MEETING DATE: January 12, 2006

SUBJECT: Tentative Tract Map 36-235 and Use Permit Application 2005-09 to Construct a 193-Unit Condominium Hotel Having Lock-off Units Totaling 225 "Keys" with Understructure Parking for 259 Vehicles with Full-Time Valet Parking Services, Spa, Pool and Patio, Meeting Facilities, Restaurant/Bar, Twenty-four Workforce Housing Units, and Associated Landscape Improvements on Five Parcels of Land Totaling Seven Acres.

FROM: *CRO* Craig Olson, Senior Planner

DATE: SEPTEMBER 16, 2005
TO: TO RHONA HUNTER AND SEAN COMBS: MAMMOTH HILSIDE 8050
FROM: CRAIG OLSON, SENIOR PLANNER
RE: ADVISORY DESIGN PANEL (ADP) REVIEW AND COMMENTS: SEPTEMBER 8, 2005

Mammoth Hillside
Internal Circulation and Project Access

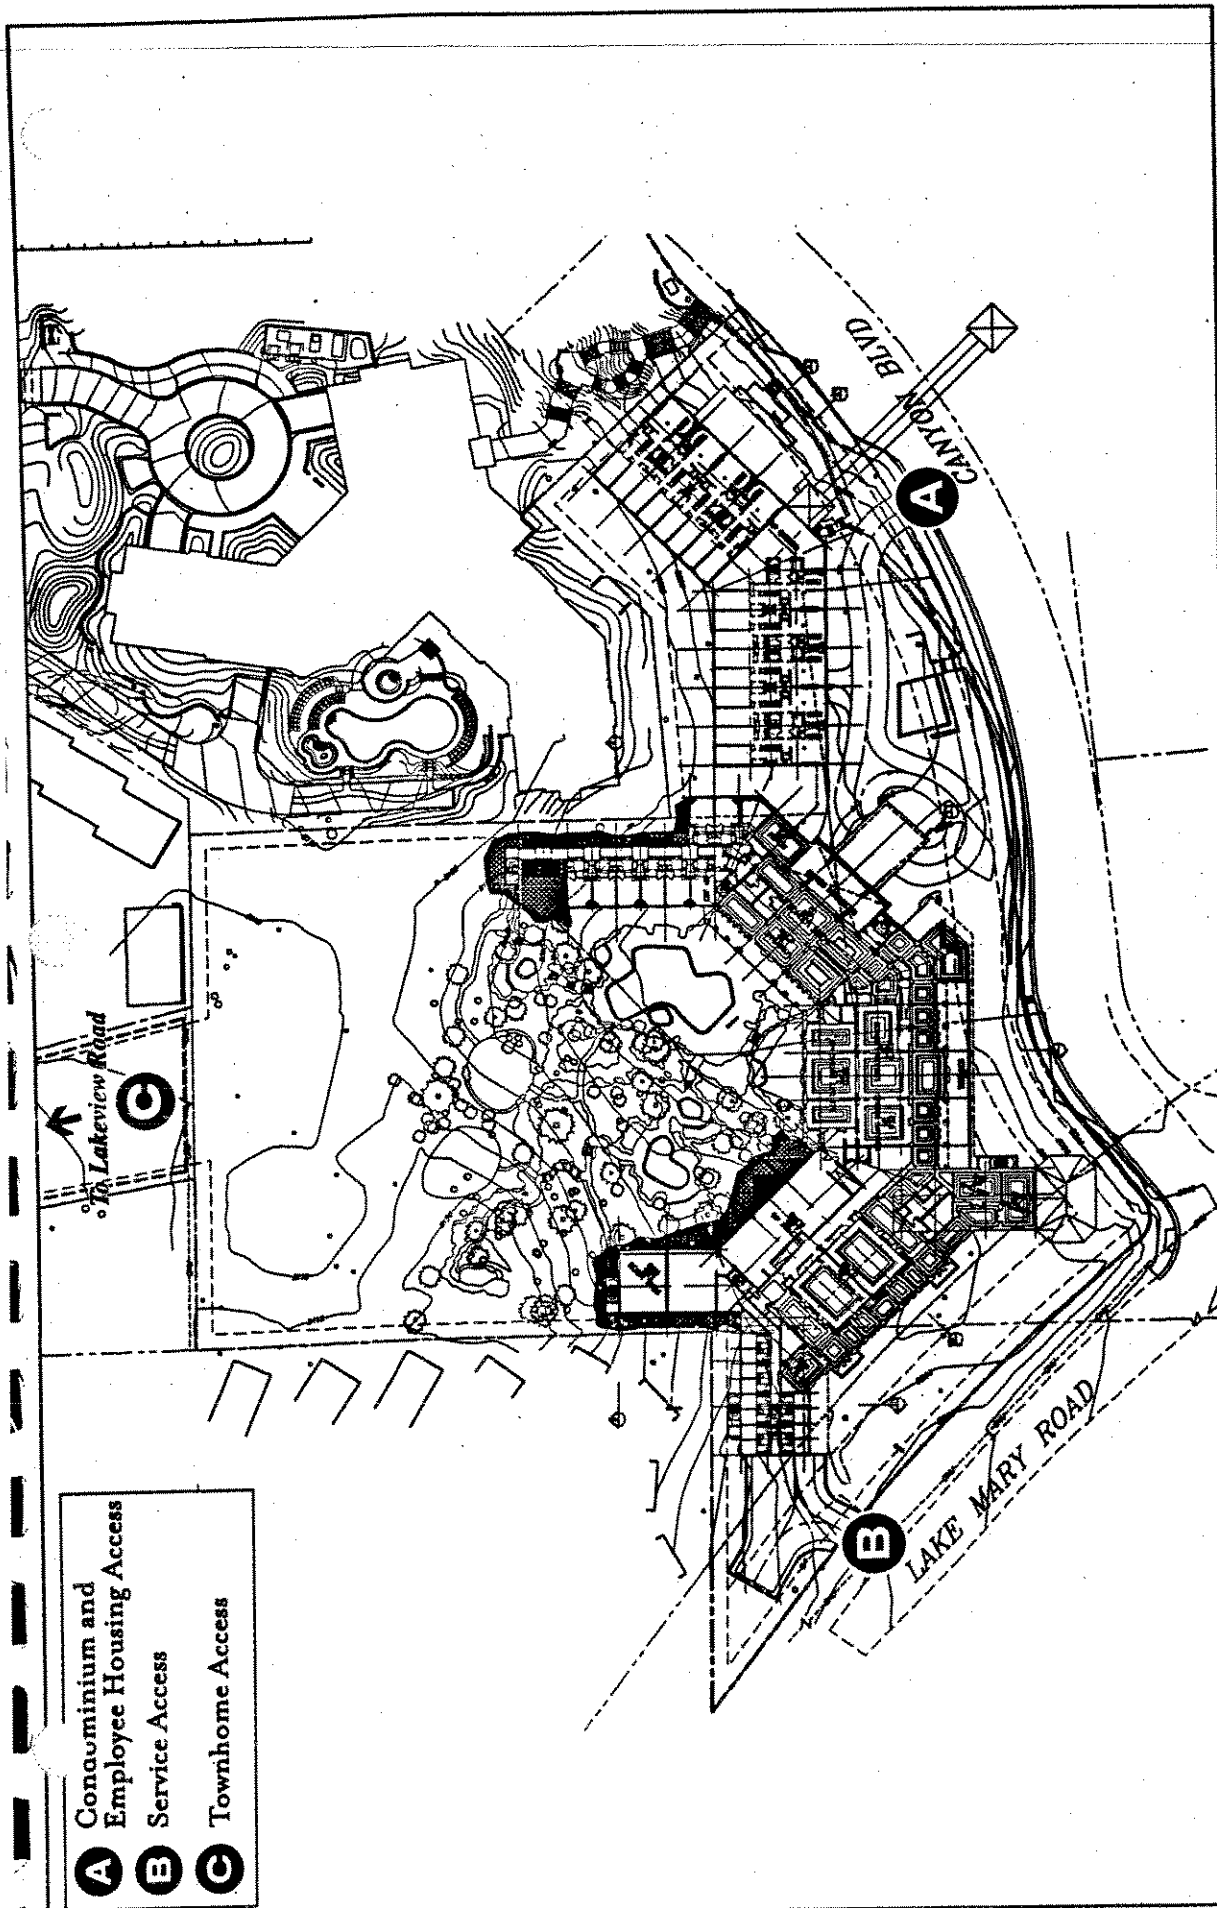
The operation of the ingress and egress locations of the project site along Canyon Boulevard and Lakeview Road has also been evaluated. As illustrated in Figure 10, three access driveways will be provided at the project site. Primary access to the condominium and employee housing units is provided via a full-access driveway on Canyon Boulevard. Secondary access locations are provided on Lake Mary Road and Lakeview Boulevard. However, the driveway located at Lake Mary Road will provide access for service vehicles; therefore, no project traffic has been assigned at this location. The access driveway off Lakeview Boulevard will provide access for the townhomes. The primary access location off Canyon Boulevard has been analyzed as part of the cumulative plus project LOS analysis.

FIGURE 11

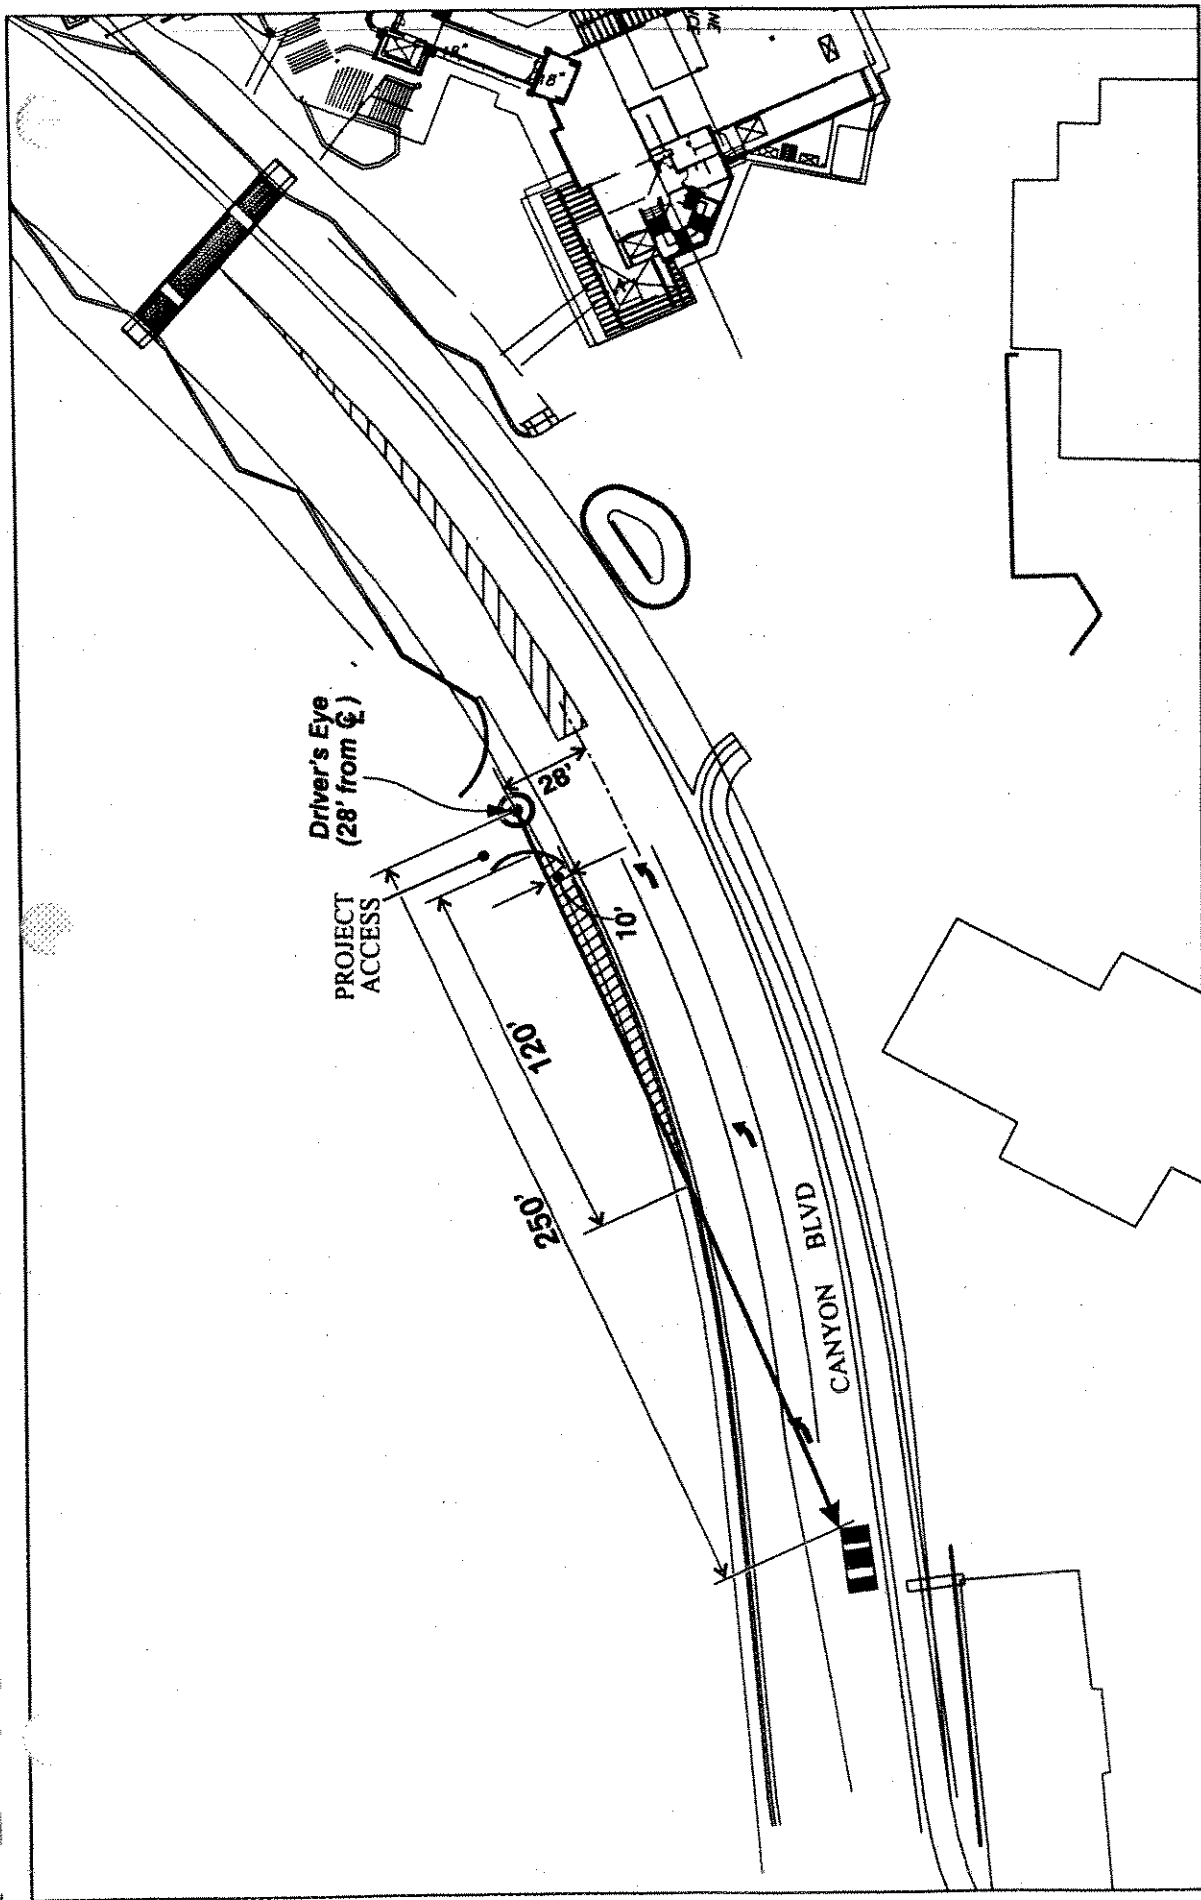
Since the primary access driveway is located within a curve, the stopping sight distance based on the radius of the curve, design speed, and superelevation of Canyon Boulevard was analyzed. Based on these parameters, a sight distance of approximately 250 feet is required from the south. The analysis indicates that to obtain the 250 feet required, an area approximately 10 feet back of the curb for a distance of 120 feet from the driveway be relatively free of obstructions (i.e., walls or landscaping) is recommended. This is illustrated in Figure 11. Sight distance/visibility to the north is adequate.
